# T ECHNICAL INFORMATION

61368

**Subject** ▶ Replacement of Tapping Screw

**For Models** ▶ 1050D

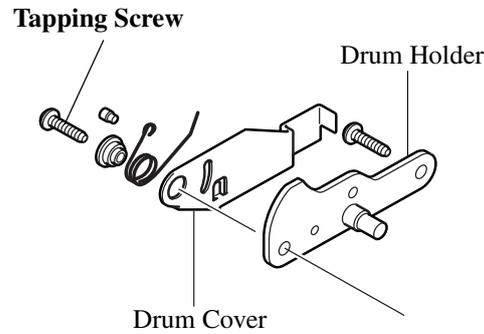
**Description** ▶ For smoother action of drum cover, Tapping Screw 4x25 has been replaced by Tapping Screw 4x20.

▶ Current	▶ New
<b>Tapping Screw 4x25</b> (Pt. No. 265999-8)	<b>Tapping Screw 4x20</b> (Pt. No. 266045-0)

Item No.	Current part	Q'ty	I/C	New part	Q'ty	Note
008	Tapping Screw 4x25 265999-8	1	←	Tapping Screw 4x20 266045-0	1

From serial No. 9124E (May, 2000)
